Office Action Summary

09/516,731

NISHITSUKA ET AL.

FIG. 2

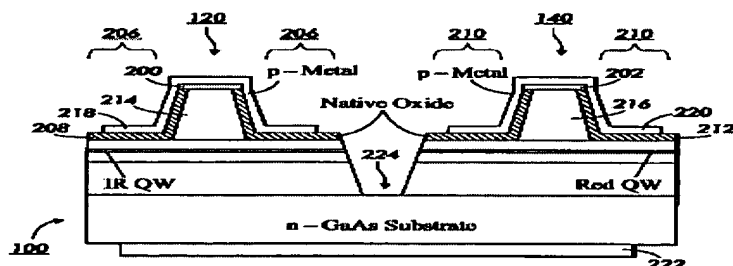
Figure 2 illustrates a semiconductor laser having two laser units with a ridge structure on opposite sides of the isolation groove (224). The semiconductor laser structure having an n-type layer, an active layer and a p-type layer with p and n electrodes, where the p and n electrodes of the laser units being electrically connected.

Figure 2 Sun et al illustrates a semiconductor laser having two laser units with a ridge structure on opposite sides of the isolation groove (224). The semiconductor laser structure having an n-type layer, an active layer and a p-type layer with p and n electrodes, where the p and n electrodes of the laser units being electrically connected.

Sun et al does not disclose providing a Schottky barrier within the electrodes.
